Docket Number:	00-AFC-14C
Project Title:	El Segundo Power Redevelopment Project Compliance
TN #:	201363
Document Title:	Cultural Resources Data to Supplement Responses to Data Request Set 1
Description:	N/A
Filer:	Dee Hutchinson
Organization:	Locke Lord LLP
Submitter Role:	Applicant Representative
Submission Date:	12/3/2013 3:51:07 PM
Docketed Date:	12/3/2013

Re: El Segundo Energy Center Petition to Amend (00-AFC-14C)
Cultural Resources Data to Supplement Responses to Data Request Set 1

Cultural Resources Data Response

(Response to CEC Request for Supplemental Data
Dated October 1, 2013)

Figure CR-1
Proposed and Historical Depth of Excavation and Disturbance for Facilities and Support Systems
 El Segundo Power Facility Modification
 El Segundo, California

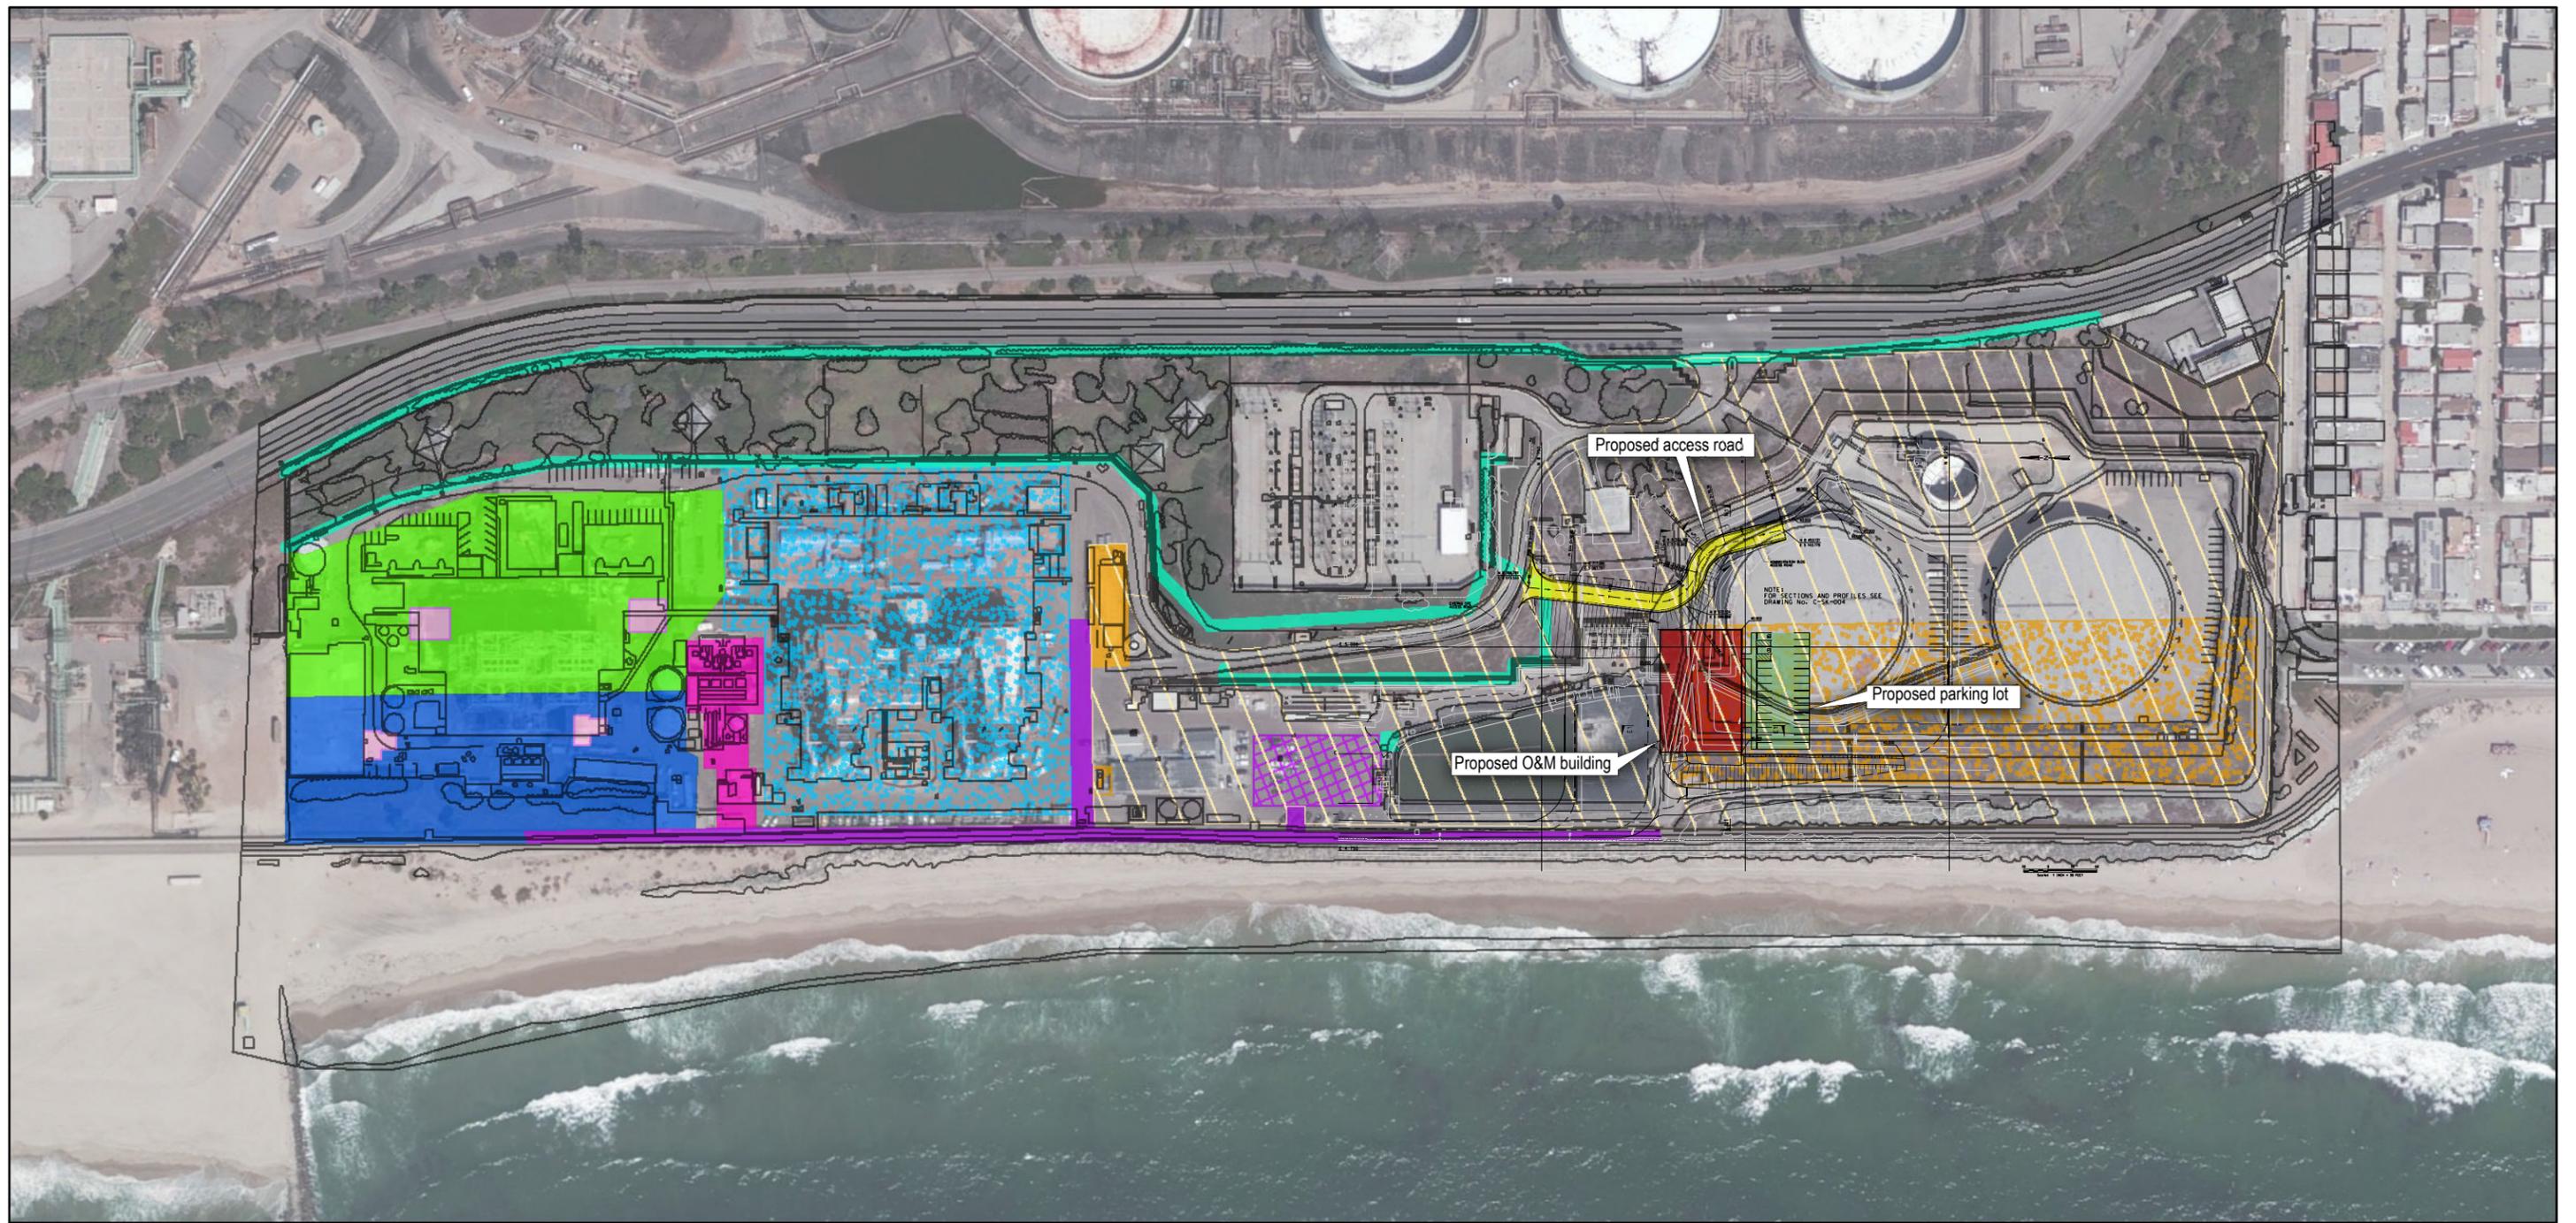
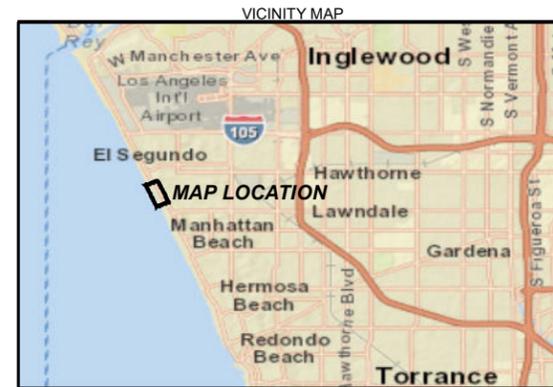
CR-A. Excavation and Fill Depth: Staff requested supplemental data regarding excavation and fill depth and other engineering details such as the locations of cultural resources on the project site, and whether native sediments will be intersected with fill. Staff also requested a figure showing the depth of previous and proposed ground disturbance.

Response: As requested, ESEC LLC has prepared Figure CR-1, which reflects the results of several important data sets that establish the project property as highly disturbed from decades of development, both aerially and vertically. This figure depicts the depths of historical ground disturbance at the project site from the 1950s to the present time; including the removal of former Units 1 and 2 and construction of Units 5 through 8, and the anticipated depths of disturbance for the proposed removal of Units 3 and 4 and construction of Units 9 through 12. As indicated on Figure CR-1, the vast majority of proposed, construction-related, ground disturbance will occur within previously disturbed soils and mechanical fill. Therefore, the potential for encountering unknown, intact, subsurface archaeological material within the planned areas of excavation is extremely low, and the potential for finding historical resources that qualify for the California Register of Historical Resources is even lower.

Based on the available ground disturbance data for the ESEC site, the ground in the modified project area is generally highly disturbed. For this reason, and because only isolated construction debris and bottles were unearthed during the recent construction of Units 5 through 8, new construction on the modified project has a low potential for impacting undisturbed soils or encountering any sensitive cultural resources.
